SUBJECT: Application for amend to License R-61, revising Tech Specs to
 reflect fuel-related changes to SAR & revised fuel
 dimensions.

Re: License No. R-61
Docket No. 50-134

WPI SAFETY ANALYSIS REPORT
Changes for Conversion to LEU

Figure 6

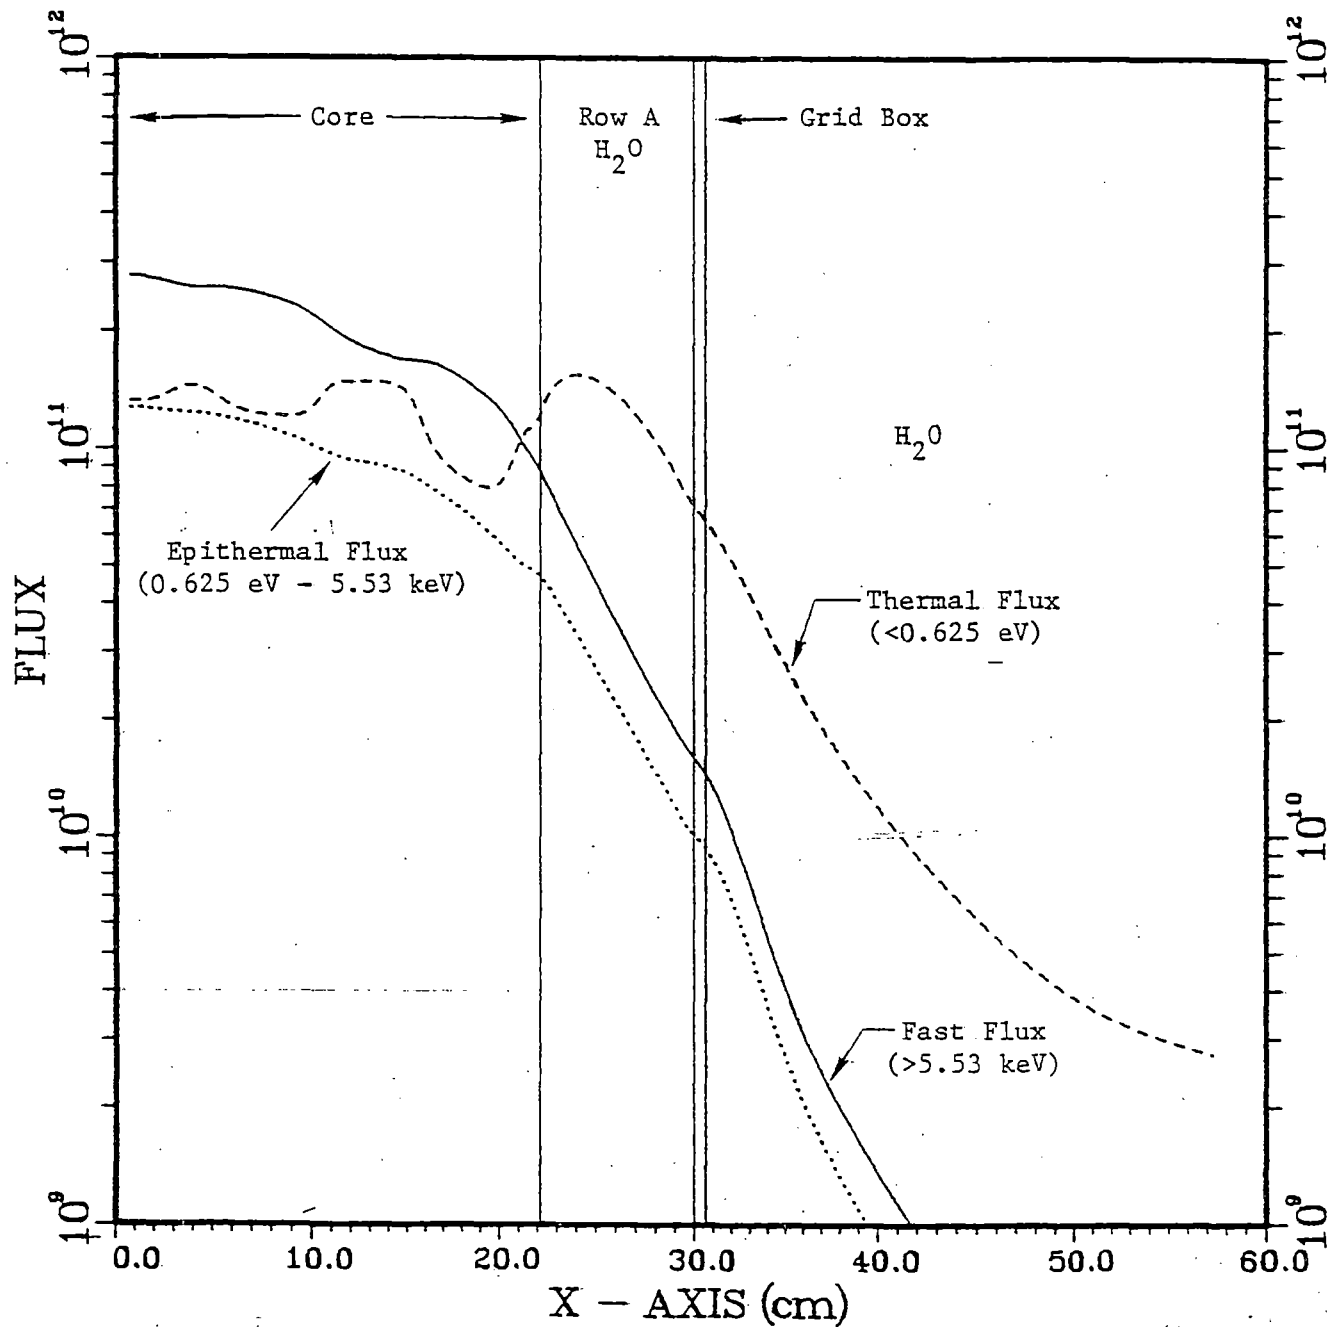
5.2.1	Critical mass and enrichment changed to LEU fuel.
5.2.2	Neutron fluxes changed to ANL calculations reflecting slight flux hardening in the LEU fuel. Note figures 6 and 7 also changed.

The distribution of the midplane fluxes in the core is shown in figure 6.

Figure 7

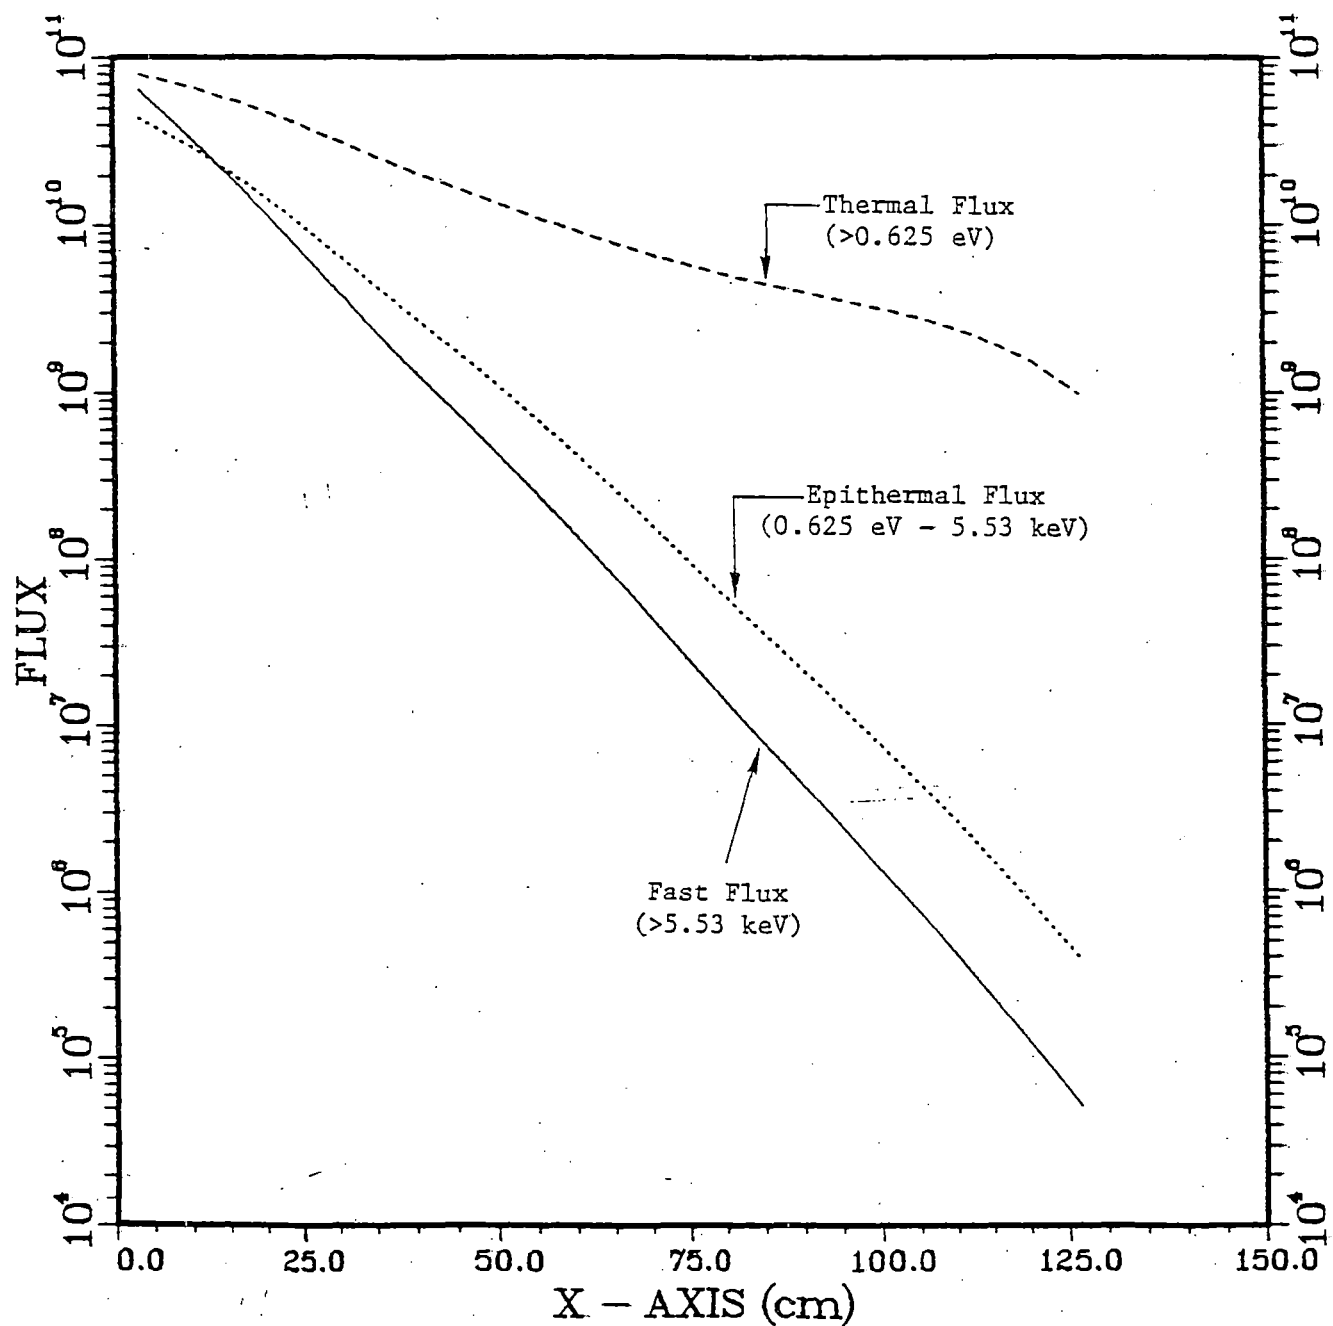
The gamma heating in the core has a peak value of about 10 watt/liter. Figure 7 shows the distribution of the midplane thermal, epithermal, and fast fluxes in the thermal column. Dose rates at 10 kw in the thermal column are as follows:

Figure 8

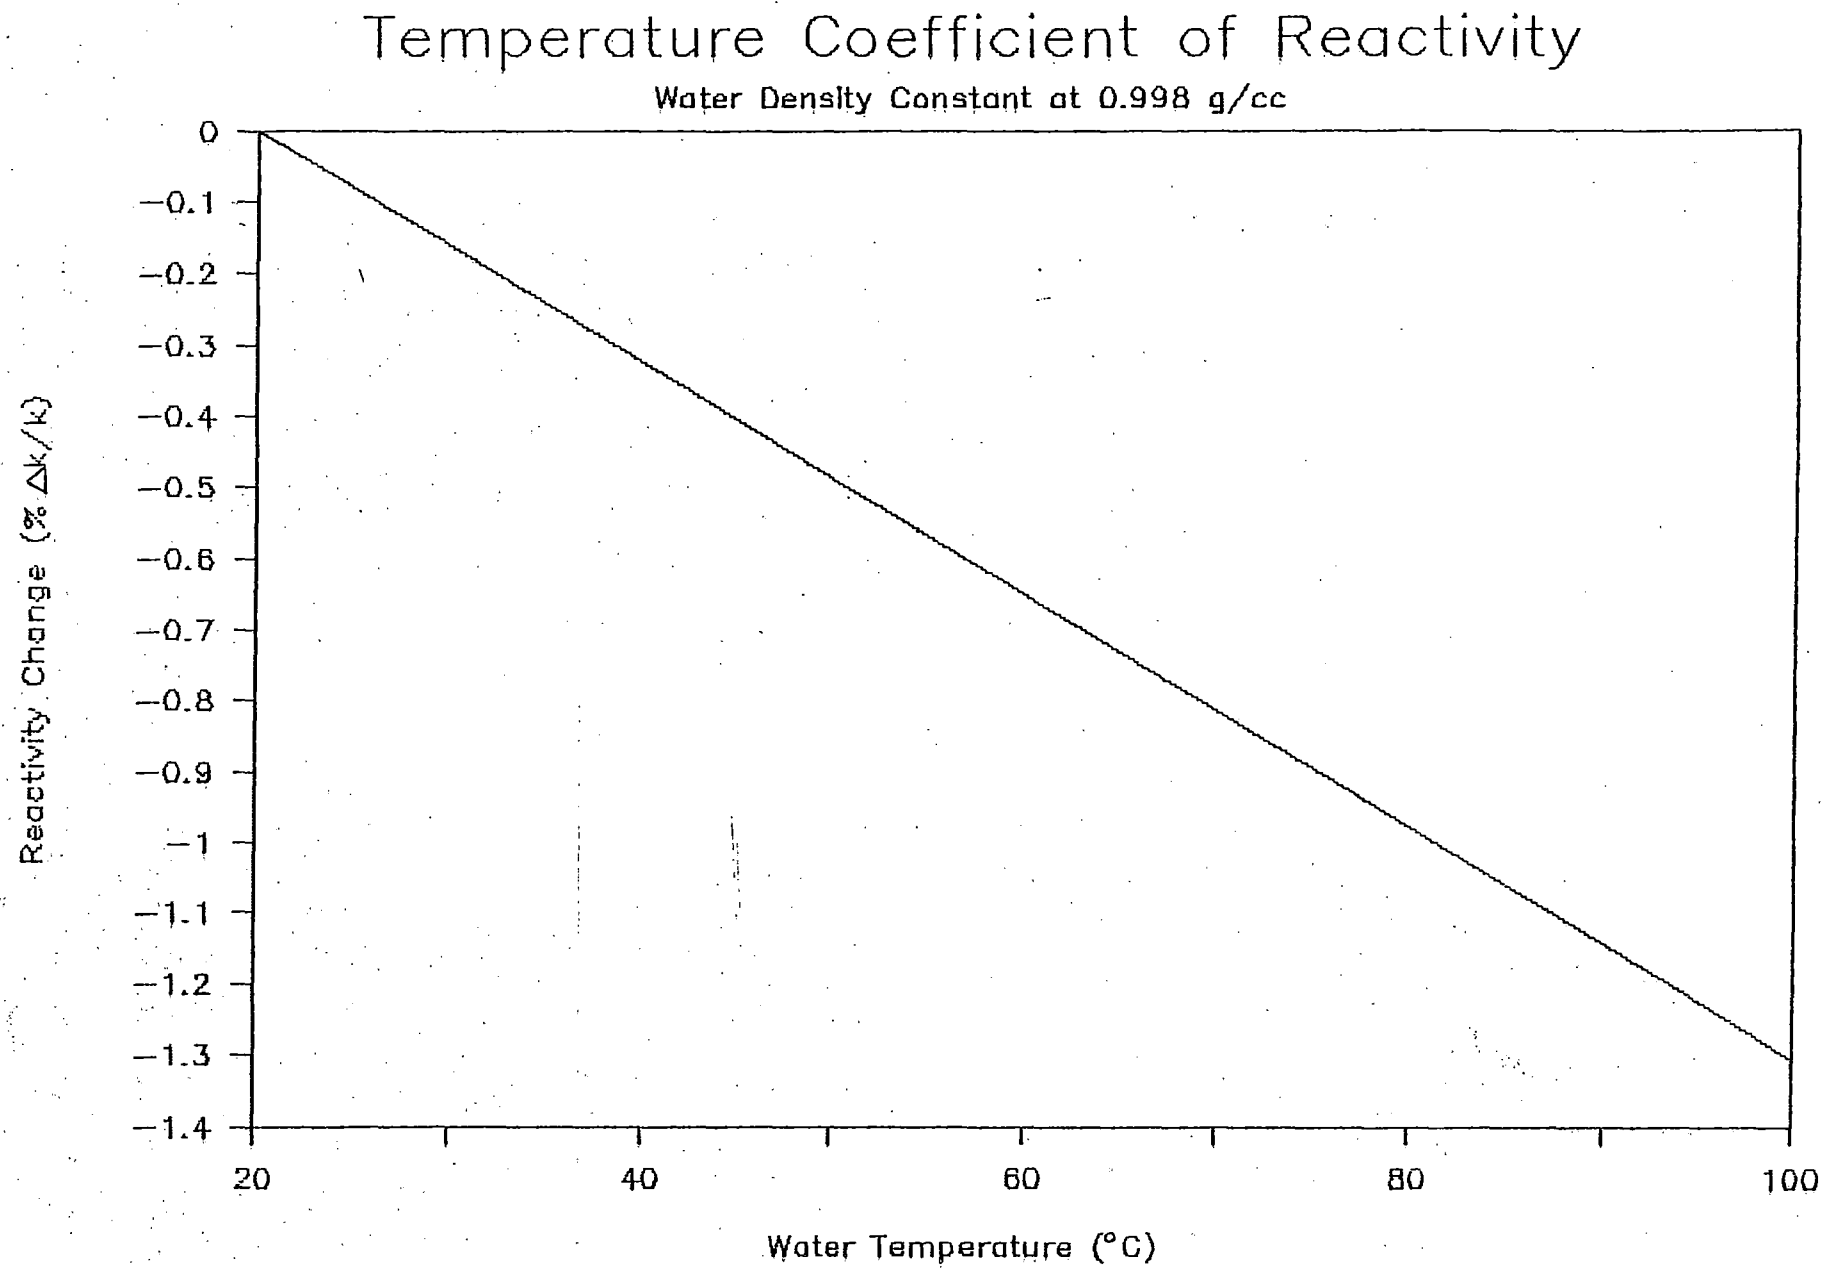
5.2.5	Section rewritten to include temperature, void and Doppler coefficients, eliminating the reference to the Spanish OPR and including the HEU values for comparison. The only changes in the values for the LEU fuel are more conservation. Figures 8 - 10 also changed.

The effect of water temperature change on reactivity is shown in figure 8. With the water density held constant, the temperature at which the maximum loaded excess reactivity would be offset is about 50°C. Figure 9 shows the effect of water density change on reactivity of the core. In an excursion, the water outside the core and in any control blade gaps would not be heated to the same temperature and density as the water flowing through the fuel elements. Therefore, the values of the reactivity coefficients shown in Section 2.3 are reasonably conservative.

Figure 10

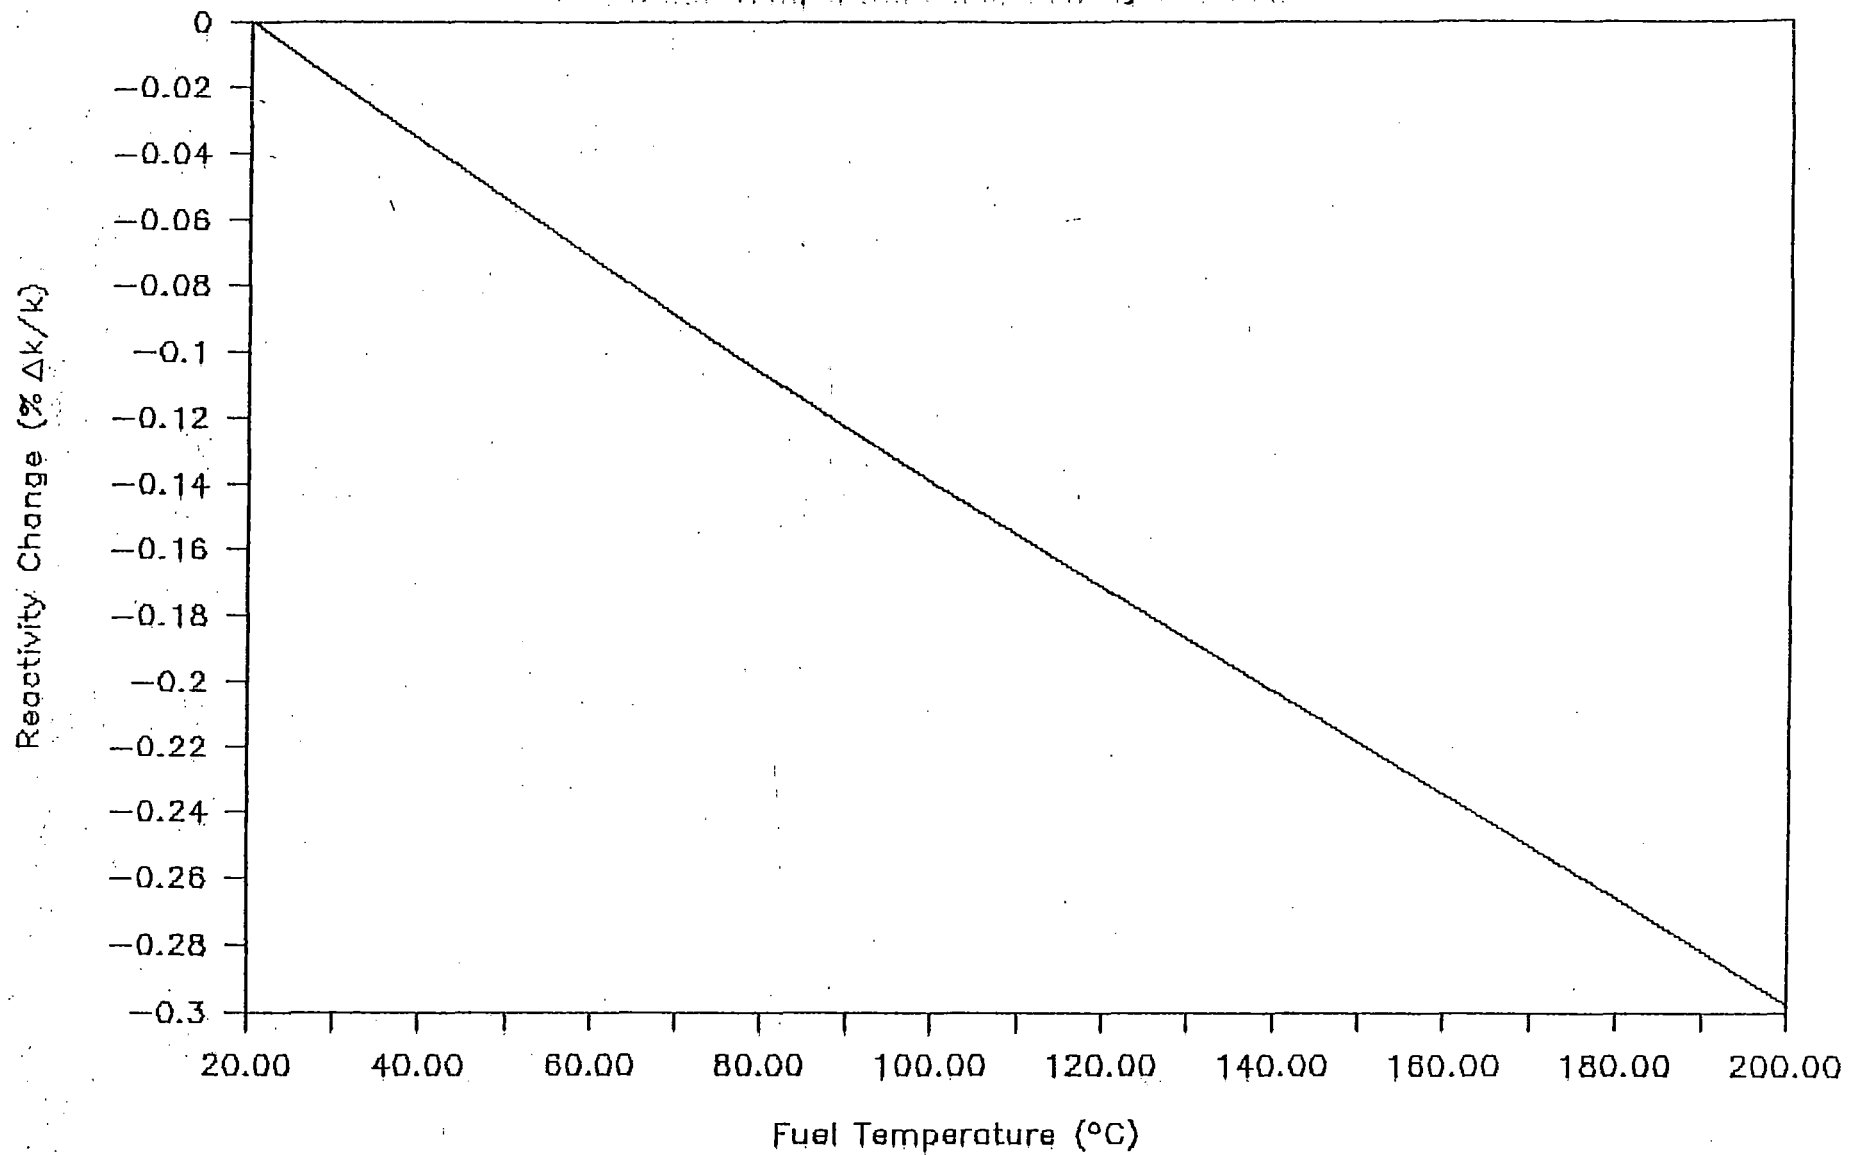
The effect of fuel temperature change on reactivity due to Doppler broadening is shown in figure 10. Reactivity effects of fuel temperature, water density, and water temperature are all additive so that any credible postulated excursion would be easily offset before temperatures could approach that of fuel damage.
